Picton High School
Site Plan Review
Recommended Modifications

Picton High School
Swept Path Assessment
On-site Bus Parking

C:\Users\tomguerni\Dropbox (TDG)\Australia Business\Australia Jobs\14500 - 14999\14584 - Picton High School Redevelopment NSW - FOR BLP\Drawings\TDG\14584-0S2C.dwg

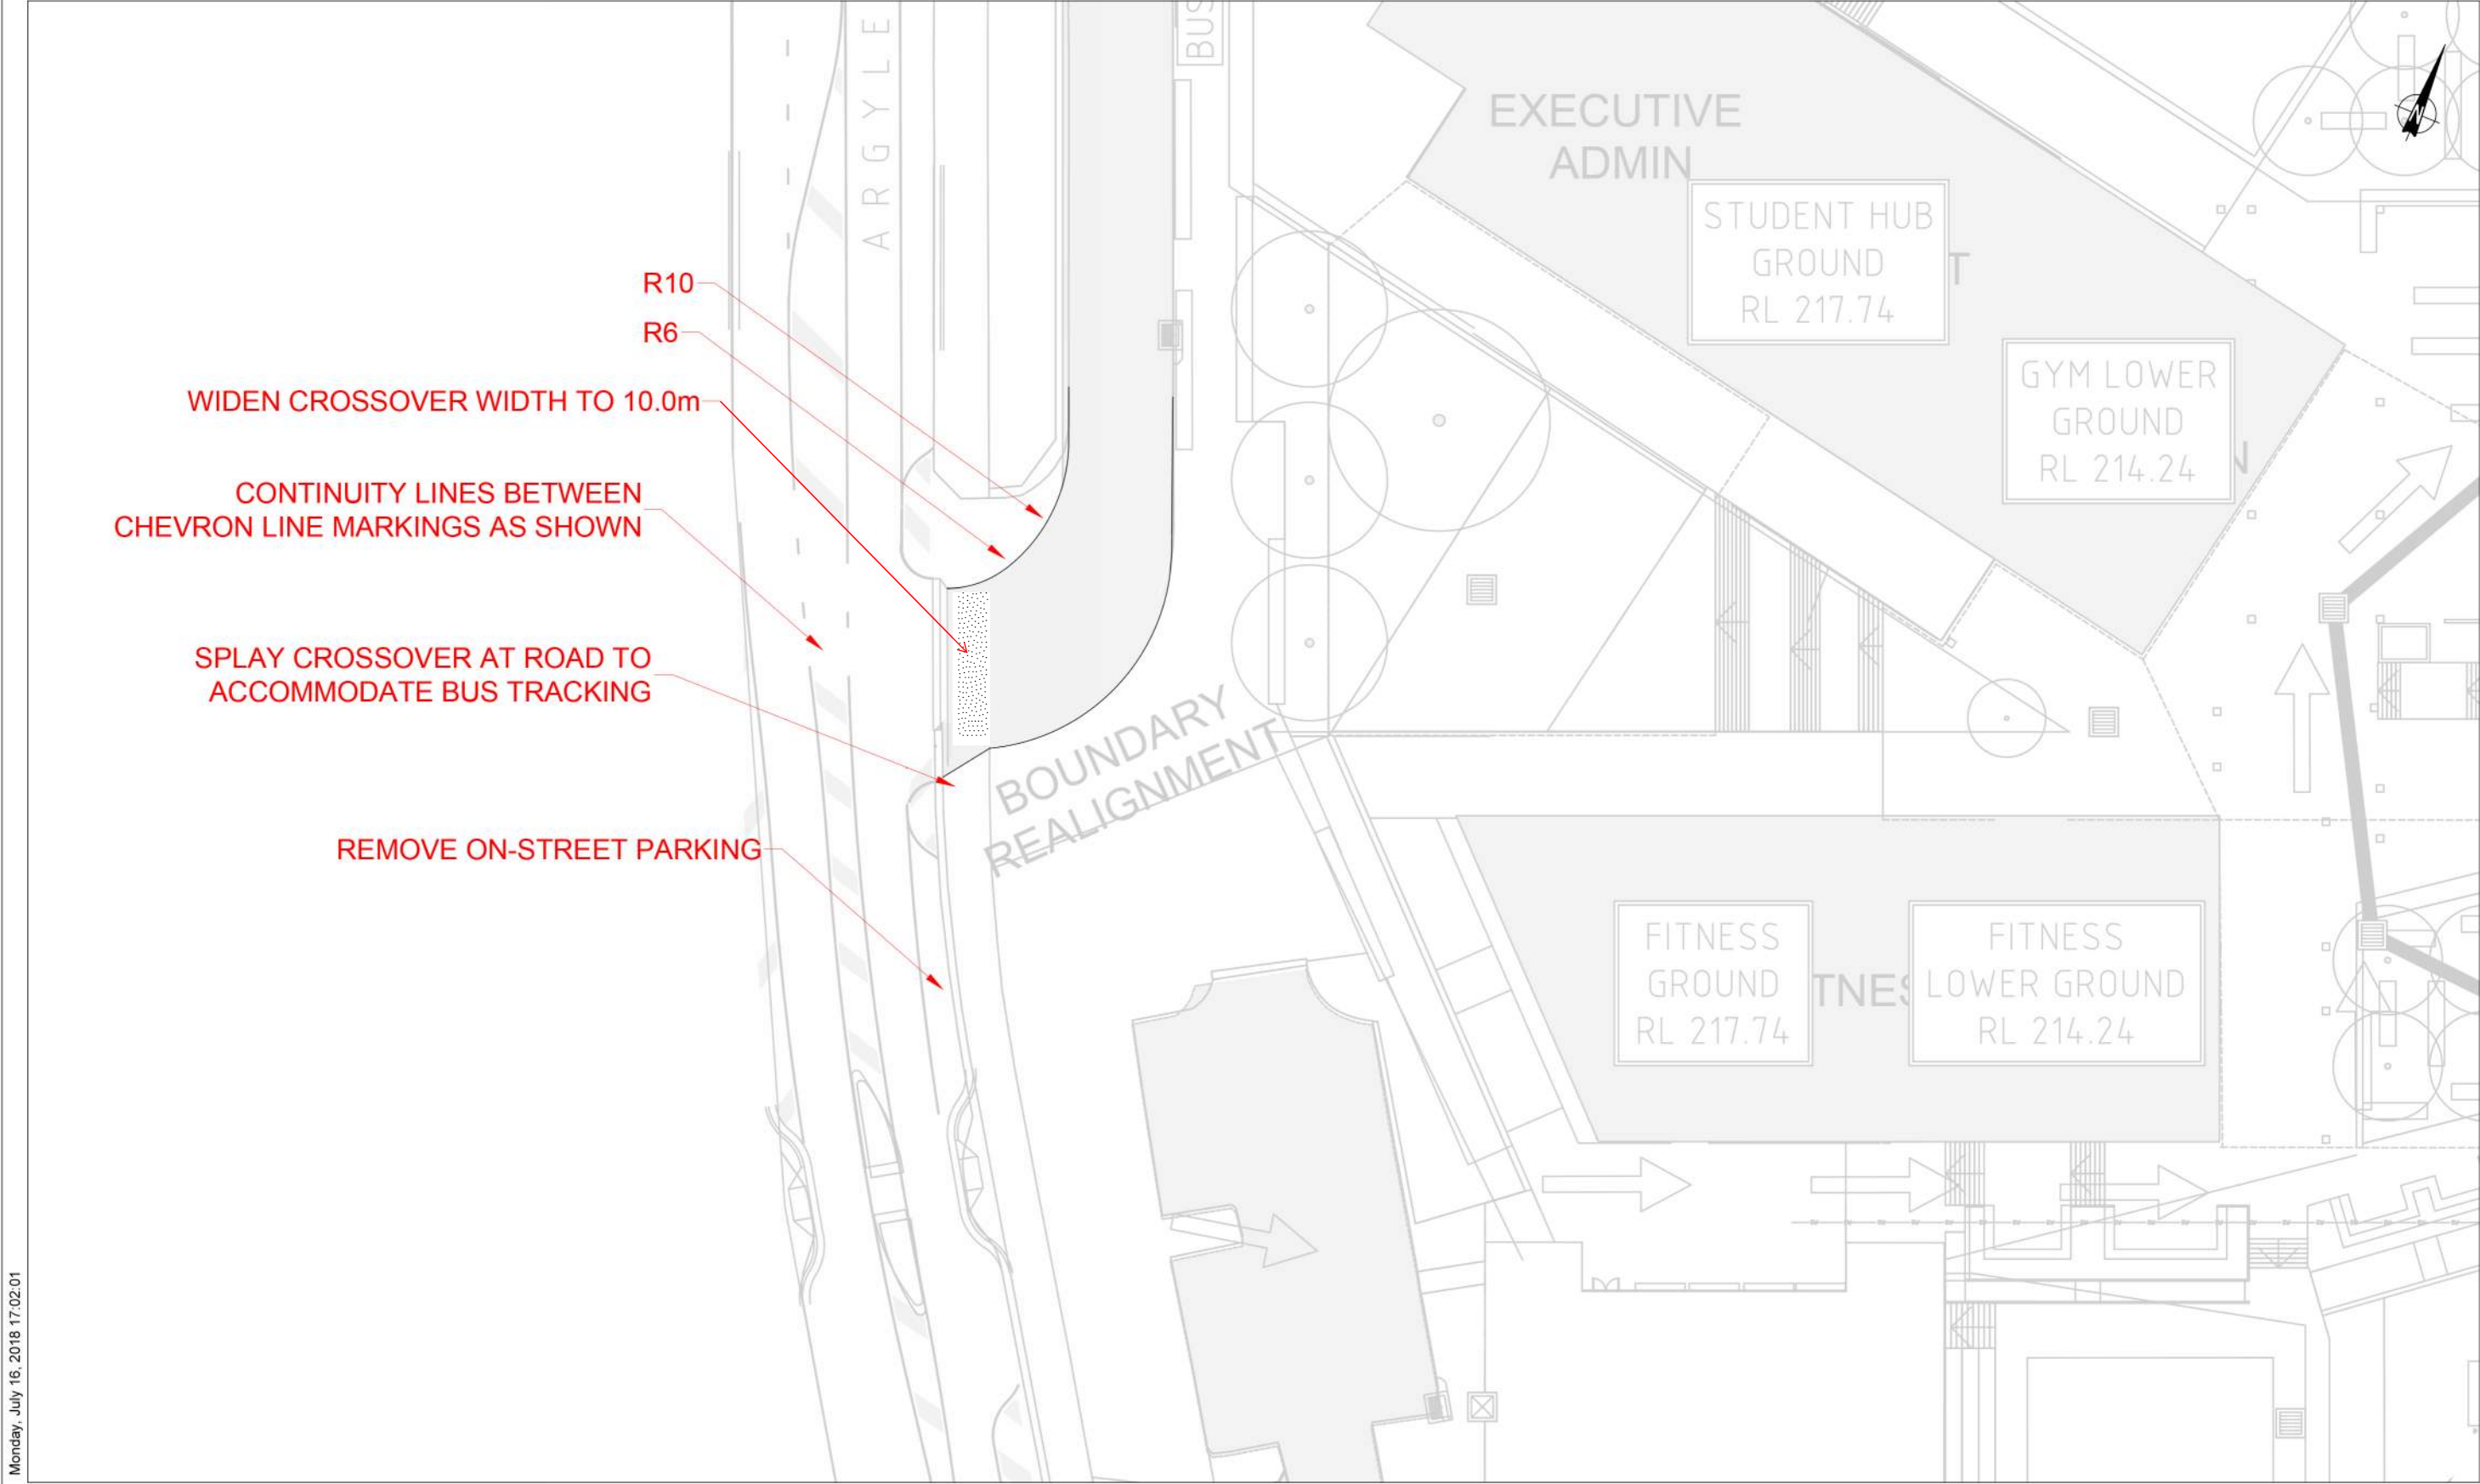
WIDEN CROSSOVER WIDTH TO 10.0m
